VN(4) Firewall Electrical Connectors Not Latching

Service Category Service

Section 375

Years	Models
2025	VN(4)

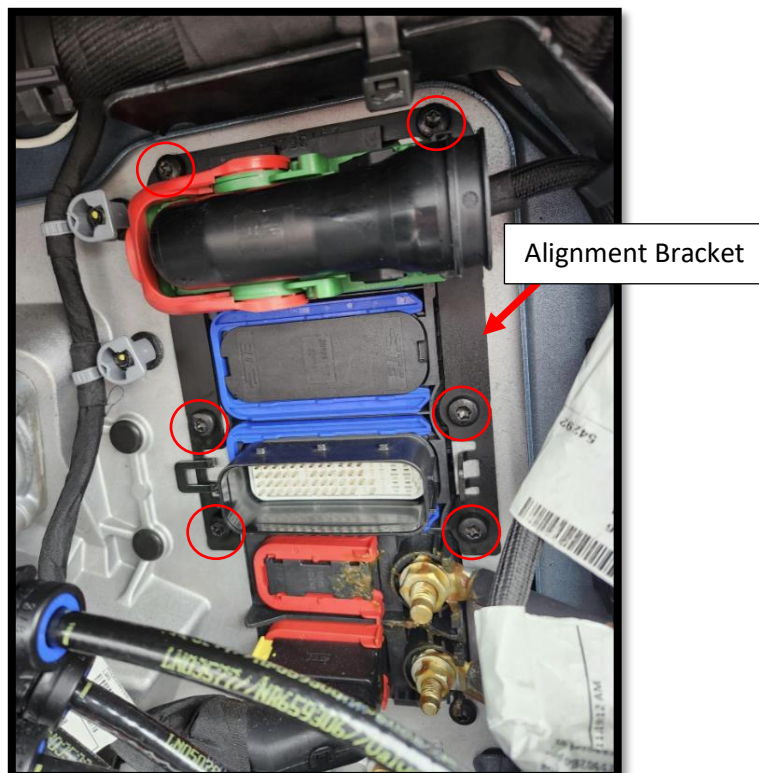
8. Remove the six screws holding the alignment bracket (P/N: 23736239) and remove the alignment bracket.

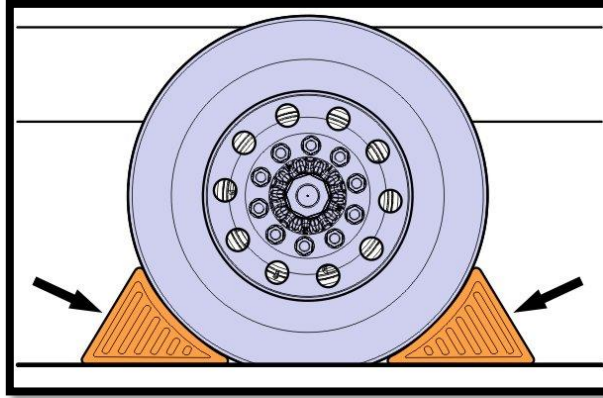
9. Once the alignment bracket is removed, reinstall the six screws.

Tightening torque
$10 \pm 1.5 \text{ Nm}$ ($7 \pm 1 \text{ lb-ft}$)
